Submission 641 (David Kriske, City of Burbank, June 17, 2020)

Burbank - Los Angeles - RECORD #641 DETAIL

Figure 1 - Extract from PEPD Schematic Drawing GE-D6501 (shows impact and final condition)

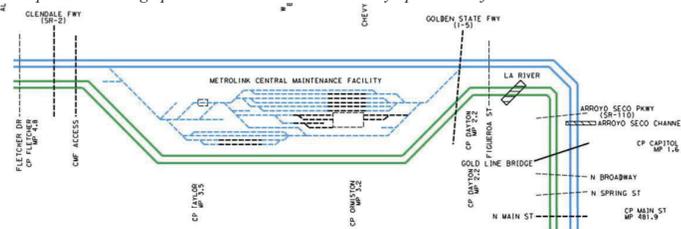
DEIR/EIS Section 2 – Alternatives, S2.5.2.8 discusses the impact of the CHSRA alignment on the Metrolink Central Maintenance Facility (CMF), see below for report extract. Also, alignment drawings MY-D1102 to MY-D1104 show the proposed modifications to the CMF that allow for the CHSRA alignment. These show significant works to the throat tracks, storage and maintenance tracks, utilities, and roads. However, the CHSRA's proposed design of the CMF modifications appear to show a reinstatement of all the current (existing condition) CMF facilities, including the provision for a wheel truing facility and two future storage tracks. The design drawings do not appear to be consistent with the S2.5.2.8 statement that these facilities are being relocated elsewhere. I also noted that there is approximately \$45 million in the CHSRA capital cost estimate as budget for the work to the CMF.

DEIR/EIS – Section 2 Alternatives - “S2.5.2.8 Modifications to Metrolink Central Maintenance Facility Metrolink’s CMF is the major daily servicing location and maintenance facility in the region. The HSR Build Alternative proposes reconfiguration of the various yard and maintenance facilities within the CMF to accommodate HSR, while maintaining as many of the existing yard operations as possible. Figure 2-27 in Section 2.5.2.2 is a schematic diagram of the existing CMF and the proposed changes, which include new mainline-to-yard track connections; partial demolition of the existing maintenance shop; a revised roadway network with reconfigured parking areas; and track relocation shifts and construction to provide additional storage capacity. Additionally, several facilities would need to be relocated or rebuilt within the CMF, including a train-washing/ reclamation building, a yard pump house, and two service and inspection tracks. Utilities would also need to be relocated with the CMF, including domestic and fire water; underdrains and reconstructed catch basins; power facilities; fueling facilities and storage tanks; and sanitary sewer systems. The proposed design would not be able to accommodate wheel truing operations or progressive maintenance bays; these would be relocated to another Metrolink facility. All other facilities and infrastructure would remain in place. The construction work at the CMF would be phased to minimize the disruption to existing operations and to maintain the key operational facilities.”
